Subject: Responses to Cygna Questions from the Independent Assessment Program
Reviews
Comanche Peak Steam Electric Station
Independent Assessment Program - Phase 4
Texas Utilities Generating Company
Job No. 84056

TEXAS UTILITIES GENERATING COMPANY
COMANCHE PEAK STEAM ELECTRIC STATION
G&H PROJECT NO. 2323
CYGNA PHASE IV CABLE TRAY SUPPORT REVIEW QUESTIONS
REF: CYGNA LTR 84056.031 DTD. 8-6-84

QUESTION 1: CYGNA LETTER 84056.031 ATTACHMENT A *item 1*

Gibbs & Hill, Inc. Job No. 2323 Client TUGCO
 Subject CABLE TRAY SUPPORTS - RESPONSE TO CYGNA PHASE 4 REVIEW
 Calculation Number SCS-101C SET 3 Sheet No. 223

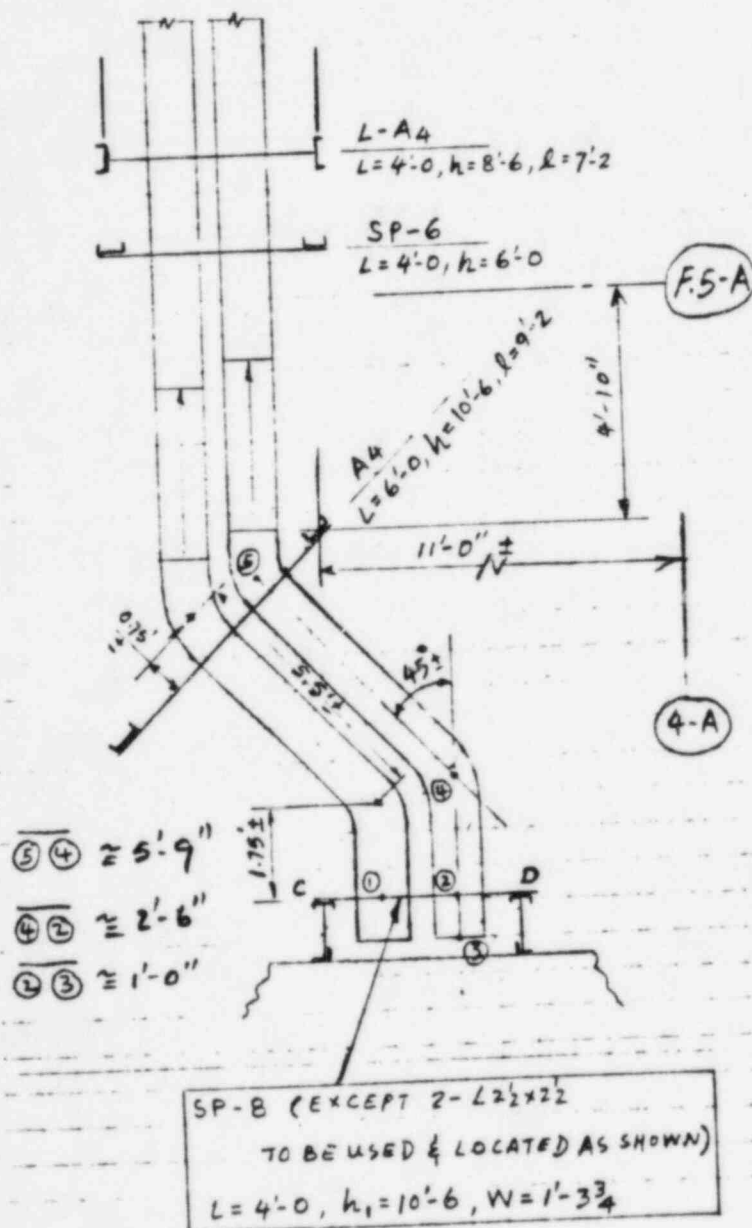
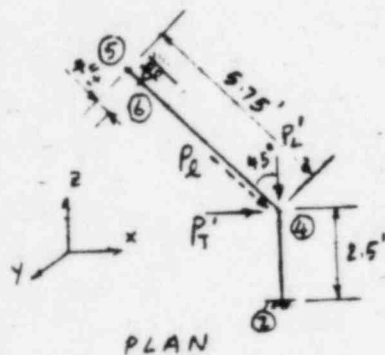
- 1) LETTER 84056.031 FROM CYGNA TO MR. J. B. GEORGE
DATED AUG. 31, 1984, ATTACHMENT A, ITEM 1

THE ADEQUACY OF SUP'T #202 (TYPE A4, MODIFIED PER CMC 4552.22) TO
SUPPORT VERTICAL AND TRANSVERSE LOADS IS SHOWN ON
SH. 4 R.O. OF REF. 4. LONGITUDINAL LOAD (45° TO E-W DIRECTION)
IS RESISTED BY SUPPORT #455 (SP-8), A SUP'T THAT
CAN RESIST LONGITUDINAL LOAD IN E-W DIRECTION AND LOCATED AT
APPROXIMATE 7'-0" S.W. OF SUPPORT #202. THE FOLLOWING CALCULATION
DEMONSTRATES THE ADEQUACY OF SUP'T SP-8 AND THE TRAY SEGMENTS.

CHECK TRAY
 CRITICAL @ ②

$$P_L = 35 \times 1 \times 5.75' \times 1.03 = 208 \text{ #}$$

From calculation SCS-101C Set 3, sheet 95

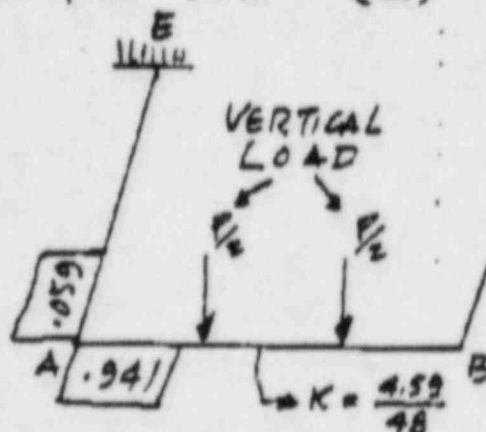
The brace design appears on sheet 94 of reference 2. The design does not consider moments induced through the fixed connection at the frame. These moments would also be induced into the anchor bolt connections but were not considered. In checking the adequacy of the member, a comparison is made between axial force and allowable axial stress. A proper comparison would require checking applied and allowable stresses.

Support 3026 is specified as a "Case SP-4, omit brace" in reference 3. The tray assembly drawing (drawing FSE-00159, sheet 3026, revision 5) specifies a brace. Cygna's walkdown indicates that a brace has not been installed and that support 3026 was located at a tray elbow. Cygna's walkdown also noted that the tray segments T12BABC15 and T12BABC16 are supported longitudinally by support 3026. The direction of this longitudinal load is perpendicular to the direction (but in the same plane) of the analyzed longitudinal loads. The effect of the loads on support 3026 from the trays listed above will be an increase in the transverse load used in the original support design. Cygna was unable to locate any calculations verifying the adequacy of the support with the brace removed and considering the effects of the imposed loads from cable trays T12BABC15 and T12BABC16.

- (e) Inadvertently P was compared with F_a instead of $F_a \times A$. However, since A is greater than 1 ($A = 2.11 \text{ in.}^2$), this does not affect the result.
- (f) As shown in item (d) above, the moment to be carried to the brace connection base angle is $0.63 K$ or $\frac{.63}{6} \times \frac{6}{4} = 0.16 K$ as additional shear and tension.

$$T = [2.69^2 + .16^2]^{1/2} = 2.694K$$

$$V = [1.79^2 + .16^2]^{1/2} = 1.8K$$

This shows that there is no significant change.

File No. 101C
 Sheet No. 3/91
 S & H Job No. 3323
 S-2303

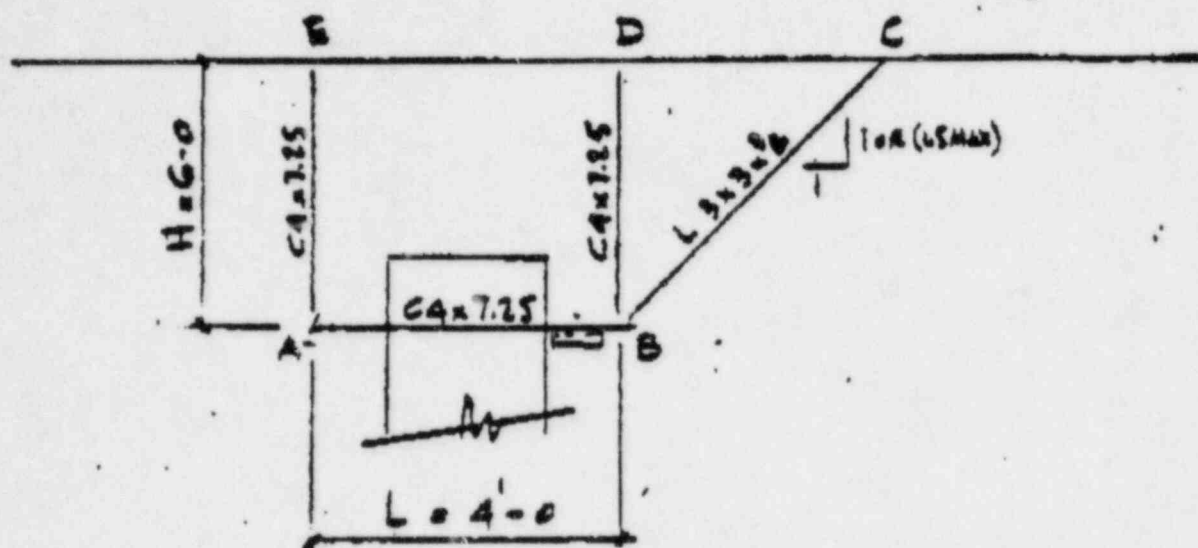
Cygna's review noted that on Sheet 91 of reference 1 the analyst assumed the end conditions for member AB to be fixed for the longitudinal and vertical loads analysis. The use of this assumption also requires that the fixed-end moments be considered in the analysis of members AE and BD. No consideration of the moment transfer to members AE and BD was made in the analysis.

- For longitudinal and transverse loads (in the plane A frame)
- (a) the frame is considered rigid and the resulting moments were considered in the design. However, when considering vertical loads, because of large differences in stiffness between the two members, only a small fraction of the fixed end moment goes to member AE as a torsional moment. Refer to the explanation at the end of the next page. Since this is very small, it is neglected.
 - (b) A load reduction of 25% was used because the span between SP 4 and the next support is allowed to be 8 ft. maximum. The share of the SP 4 is $\frac{1}{4} \times 8$ ft cantilever portion of tray (2'-0 max.). $4+2=6'-0$ which corresponds to 25% reduction.
 - (c) Column 8 of SCS-101C Set 3, sheets 92 and 93 should read:

Question 2.1.1 (cont)

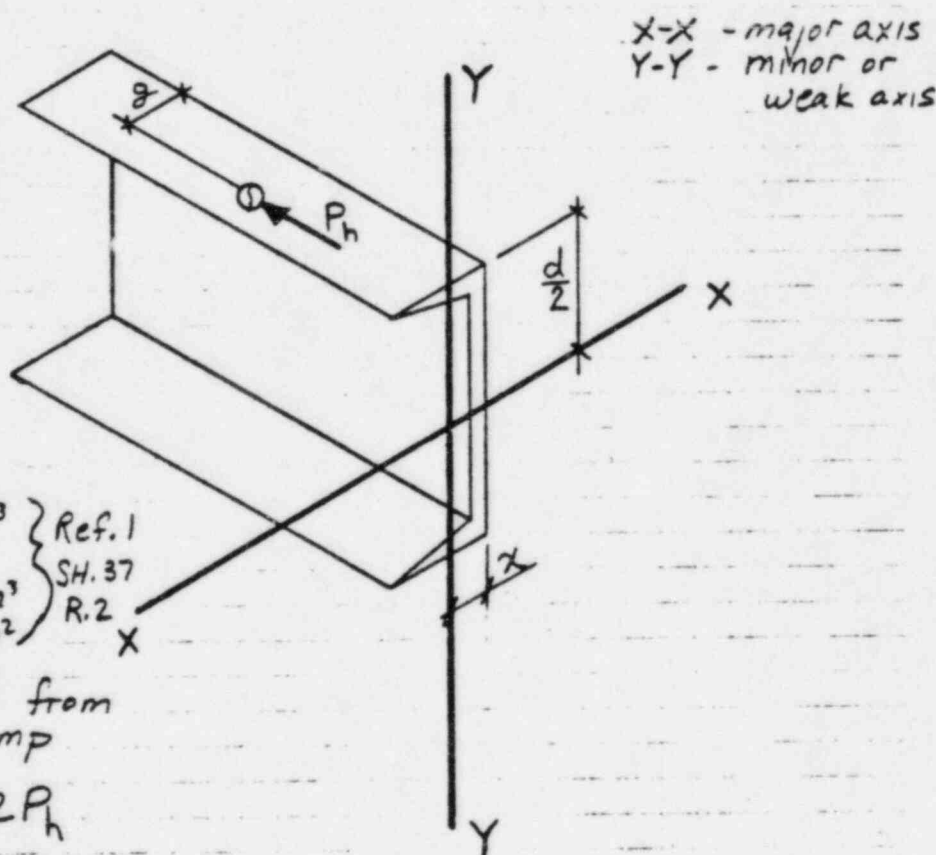
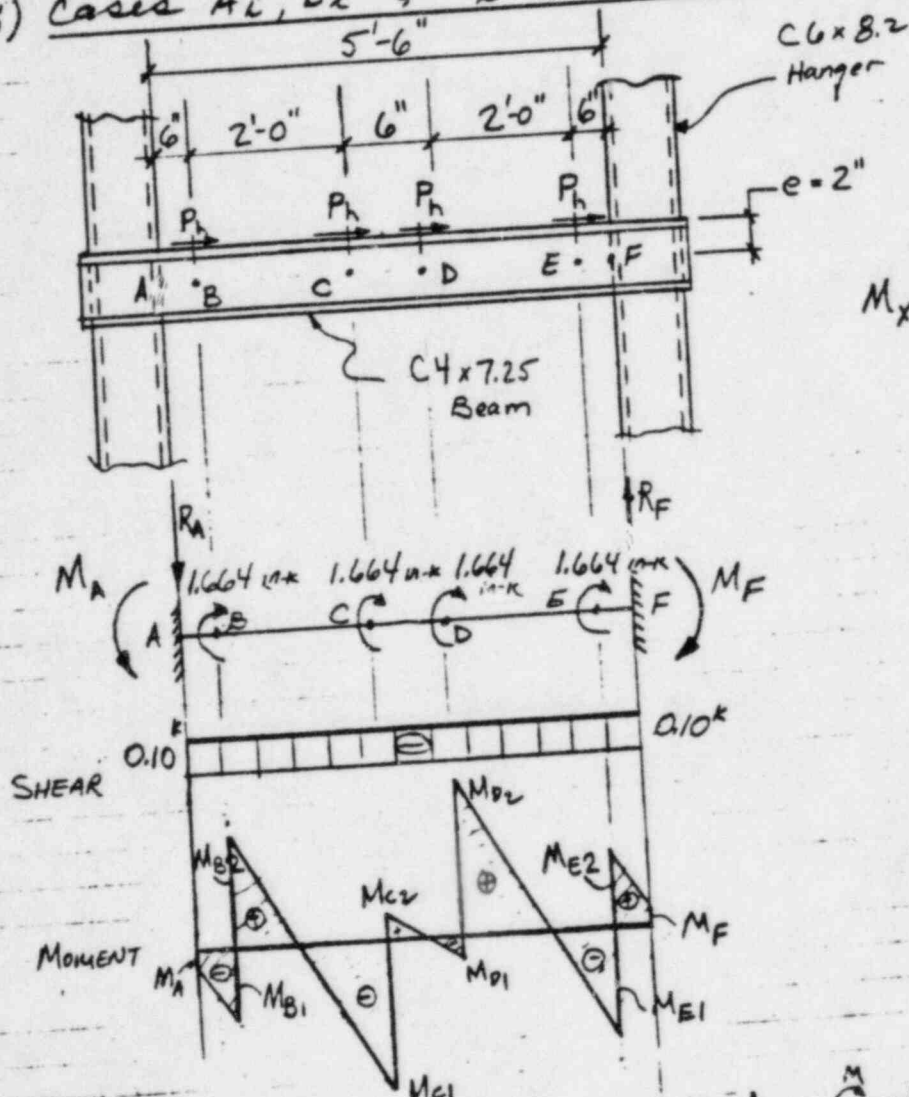
As noted in Figure 2B, the location of the transverse load, P_h , is eccentric to the major axis by a distance $d/2$, where d is the channel depth. The effect of this eccentricity is an increase in major axis bending. Minor axis bending will occur because P_h is eccentric to the minor axis by a distance of $(g-x)$ where g is the gage distance and x is the location of the neutral axis relative to the back of the channel web.

Purpose of Calculation - To provide justification for neglecting the effects of eccentric transverse loading on beam channel sections typically used in the cable tray support designs.

$$M_{xx} = 2P_h = 2(.832) = 1.664 \text{ in-k}$$

Question 2.1.2 (cont)

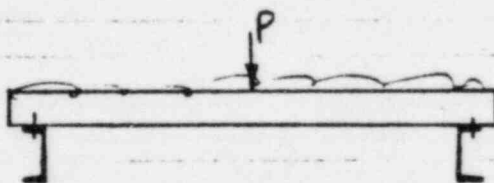
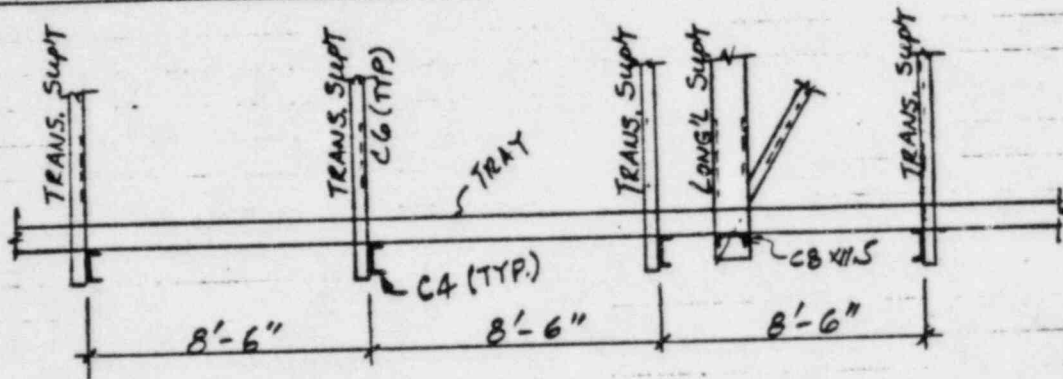
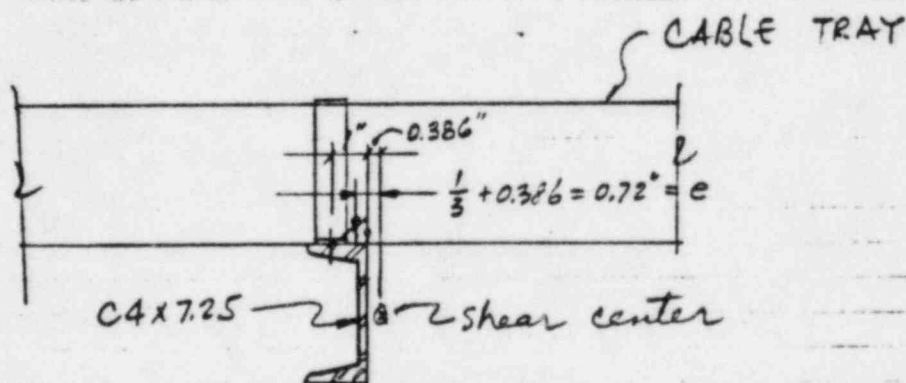
As shown in Figure 2C, vertical cable tray loads are applied eccentrically to the shear center of the channel section which induces torsional moments into the beam. Cygna has noted that only beam members for Regular Case cable tray supports Details A₁, B₁ and C₁ and Detail SP-7 with brace have been analyzed for the effects of eccentrically applied vertical loads. Cygna is currently reviewing these calculations. No other cable tray supports have been analyzed for the effects of torsion due to vertical loads.

Torsional stresses caused by loads acting in the plane of the minor axis of a channel member are generally neglected in engineering practice if the support arrangement is symmetrical about the center line of the system as illustrated below:

That the cable tray stiffness is much greater than the beam stiffness. The cable tray is actually resisting the entire torsional effects due to the vertical loads.

Question - 2.1.3: (CYGNA LTR #4056.031 ATTACHMENT A)
TORSION DUE TO LONGITUDINAL LOADS

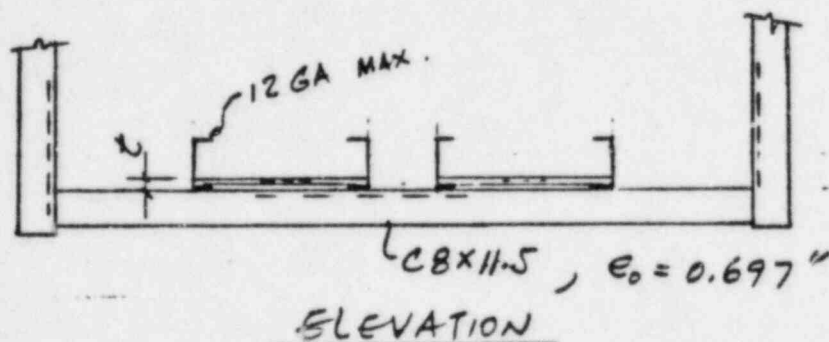
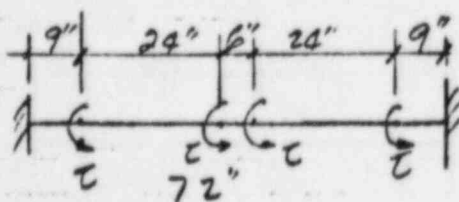
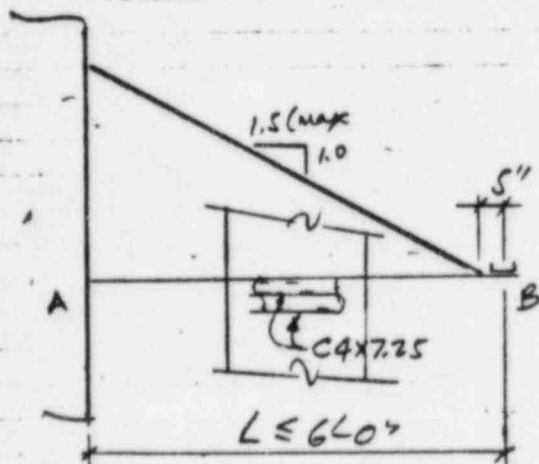
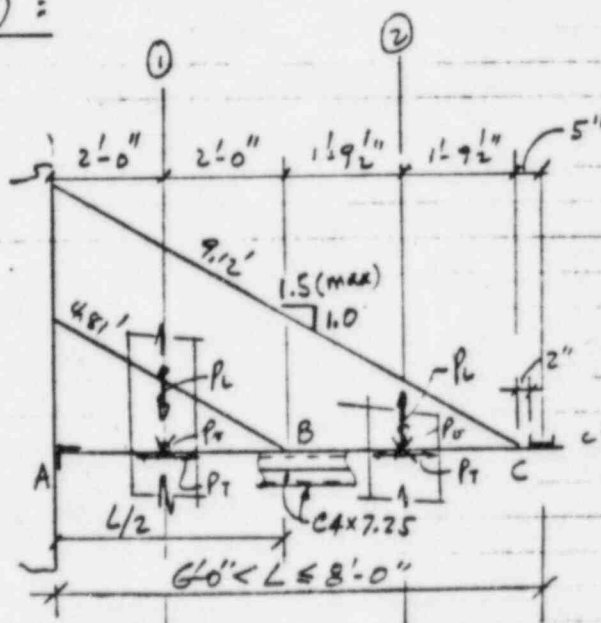
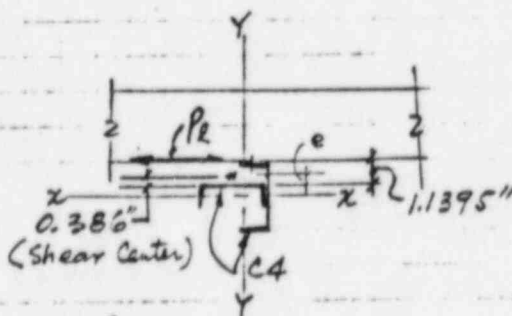
As shown in Figure 2C, longitudinal cable tray loads are applied eccentrically to the major axis (X-X) of the channel section which induces torsional moments into the beam member. Cygna has noted that only Detail SP-7 with brace has been analyzed for the effects of eccentrically applied loads.

Purpose: To provide justification for the longitudinal cable tray support beam to resist the additional torsional effects due to the eccentric longitudinal tray loads.

$$t_{max} = 0.1084 + \frac{13}{16} = 0.9209"$$

$$t_{max} = 0.1084 + \frac{3}{8} + 0.0516 = 0.535"$$

QUESTION 2.2 (CONT'D)

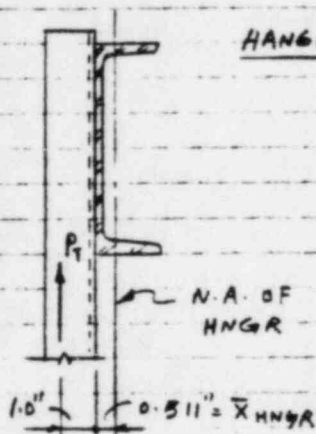
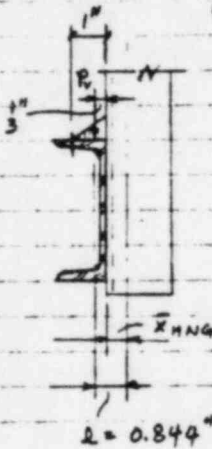
The cable tray supports are primarily constructed of channel sections for the hanger and beam members and angles for bracing members. (For Cygna's concerns regarding angles, reference Cygna's letter 84056.027, question 2.) Figure 2D shows the eccentricity between the neutral axis of a typical beam and hanger connection. Cygna has noted that the effect of this joint eccentricity has not been considered in the design calculations.

- i) EFFECT OF ECCENTRIC CONN. FOR THE TRANSVERSE LOADS:
 REFER TO THE STIFFNESS ANALYSIS SHOWN ON SH. 156 TO 158 R.4

HANGER $\Delta M^T = P_T \times \frac{L}{12}$
 REF. TO SH. 160 R.4
 $\Delta P_T = 0.2322 \Delta M^T = 0.2322 P_T \times \frac{L}{12}$
 $= 0.0193 L P_T$

ii) EFFECT OF ECCENTRIC CONN. FOR THE VERTICAL LOADS:
